M CLASS INTERNAL REVIEW REPORT

PLATO

TECHNICAL & PROGRAMMATIC REPORT

prepared by/ <i>préparé par</i>	Review Board
reference/ <i>référence</i>	SRE-PA/2009.081
issue/ <i>édition</i>	1
revision/ <i>révision</i>	1
date of issue/ <i>date d'édition</i>	12 November 2009
status/ <i>état</i>	
Document type/ <i>type de document</i>	TN
Distribution/ <i>distribution</i>	Internal

Figure 2-1: Time line of the GAIA CCD programme.

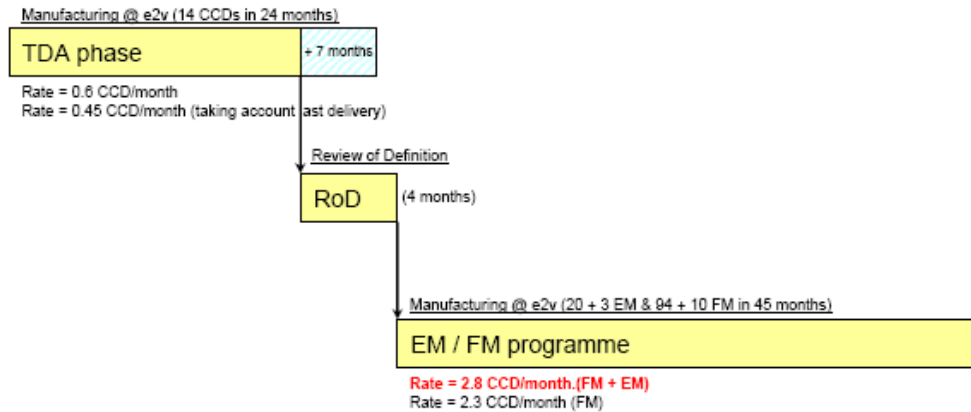
Given the high number of CCDs to be produced in all studies, a key element which will impact the spacecraft development is their manufacturing time. In order to evaluate the proposed schedules for the development and production of the potential PLATO CCDs, the GAIA CCDs development, manufacturing and test rate was used as a benchmark. In Figure 2-1 the time line of the GAIA CCD program is shown. Based on that, a reasonable production rate is about 3 CCDs per month.

When the Gaia bench mark is applied to the two industrial studies and the PPLC the following schedule can be deduced for the Phase B2/C/D:

Astrium:	214 CCDs (BB + EM + FM + FS)	6 years
Thales:	128 CCDs (EM + FM)	3.6 years
PPLC:	168 CCDs (FM)	4.7 years

Figure 2-2: Astrium design with two mirrors.

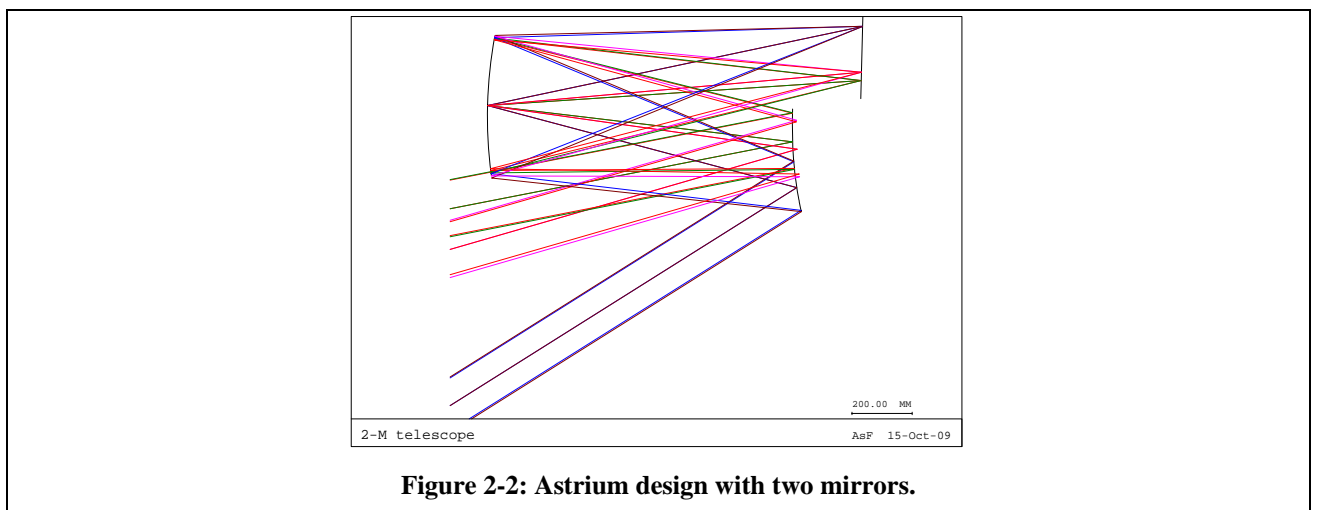
A major feature of the proposed reflective design is that the mirrors shape is very difficult to manufacture. Oblate spheroids with high orders are used and there is a large departure from best fit sphere (M1: 1.129 mm). Tight mechanical tolerances are also required and adjustments will be necessary during integration.

The reflective telescopes foresee 24 mirrors in SiC. Whether CVD coating can be avoided is not obvious. There are two types of mirrors, the primary or M1 has a very complex surface to obtain. The total area to polish is 5.6 m² which more that twice the total area of the mirrors in Gaia. A rough estimation of the time needed for completing one mirror M1 only is about 27 month. The secondary mirror M2 should be faster to produce. Assuming the mirrors are produced by two different companies and at least four can be done in parallel, the time to produce all M1 is more than 6 year.

Figure 2-3: Thales design based on 6 spherical lenses.

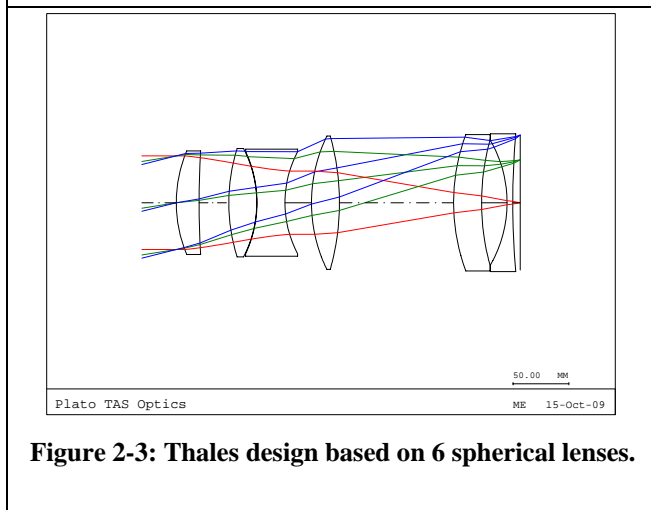
The refractive design proposed by Thales is simple and compact but two aspects, radiation hardness and thermal performances and stability at low temperature are not properly accounted and my generated surprises in the detailed design phase.

Figure 2-4: PPLC design based on 6 lenses of which two are aspheres.

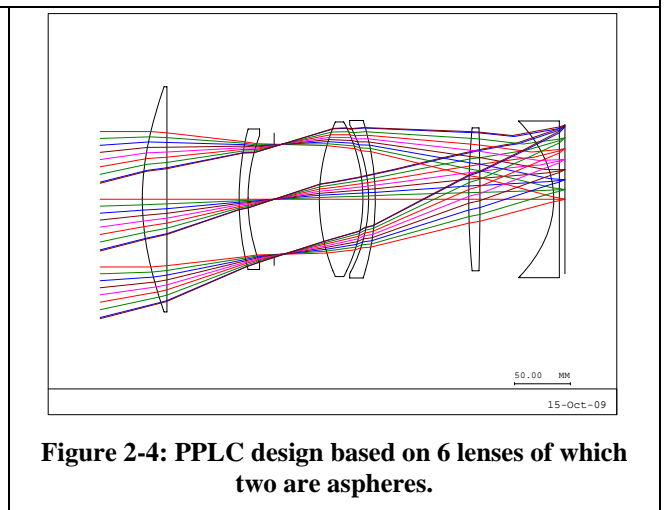
The refractive design proposed by the PPLC generate more concerns associated to the size of the front lens (diameter is 200 mm) and the selected material (BaF2)

- Korth is biggest manufacturer in Europe: it would need 2 to 3 months to grow a BaF2 ingot of the required quality and size to cut 1 or 2 lens blanks. In addition Korth would have to update their facilities to cope with the lens size.
- Sensitive to thermal shocks but soft: required polishing control to avoid break.
- Hygroscopic (solubility: 0,17 g/100g @23°C) but it is controllable with appropriate environmental control
- Two aspherics lenses with difficult shape: conics with high orders and large departure from best fit sphere

Figure 3-1. Estimated duration of phases B2/C/D for PLATO.

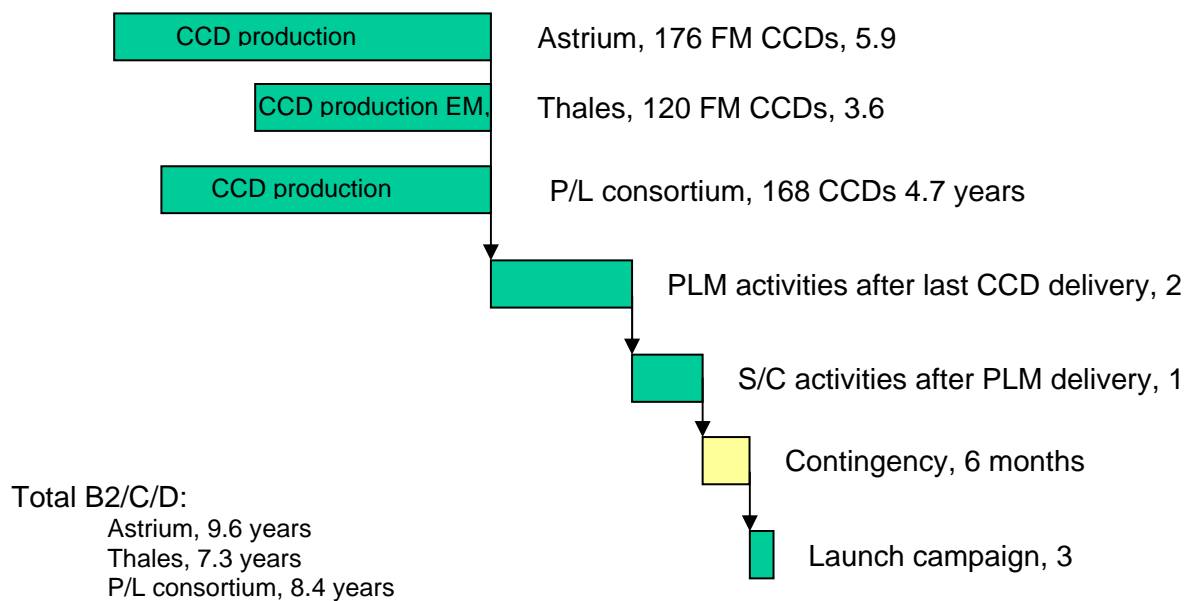
Figure 3-1 shows the estimated schedule according to the findings of the review board, taking into account the CCD procurement estimates presented earlier in this report. This estimation assumes that the CCDs will be on the critical path.

Based on the above and considering that, as explained in paragraph 2.2.1, the review team estimation of the CCDs production time for the Thales configuration is likely underestimated, a “realistic” S/C development time is 8.5 to 9.5 year. The driver is the huge number of CCD to be developed. In this analysis it is assumed that the optics (whether reflective or refractive) will take less time. This is still to be confirmed in particular for the reflective system.
